**Source:** Prestolite Leece-Neville Heavy Duty Systems  
**Bulletin No:** TSB-1214 **Date:** July, 2022  
**Models:** 4900 pad mount remote regulator.  
**Subject:** Terminal ID from 4900 to BLP4000

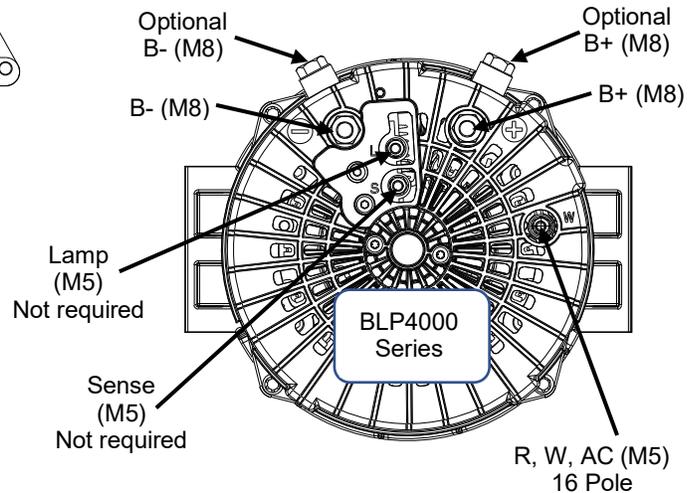
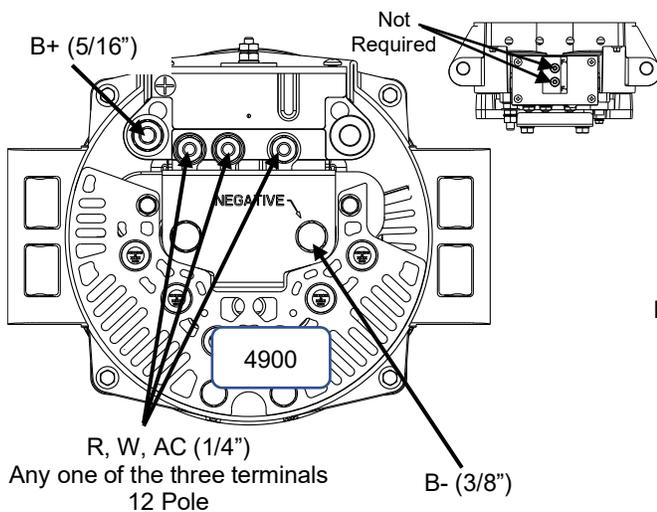
This document will help identify terminal location variances.

Note: Wire termination and routing will require changes.

Remote regulator currently used in the application will no longer be used as the replacement BLP4000 alternator has its own internal voltage regulator.

Disconnect wires connected to the 4900 F+ and F- terminals and insulate these wires to prevent shorting and secure out of the way. See TSB-1185.

4900 series alternators listed on this document are grounded earth return where the BLP4000 series replacements are insulated return. Depending on the vehicle wiring a ground strap maybe required.
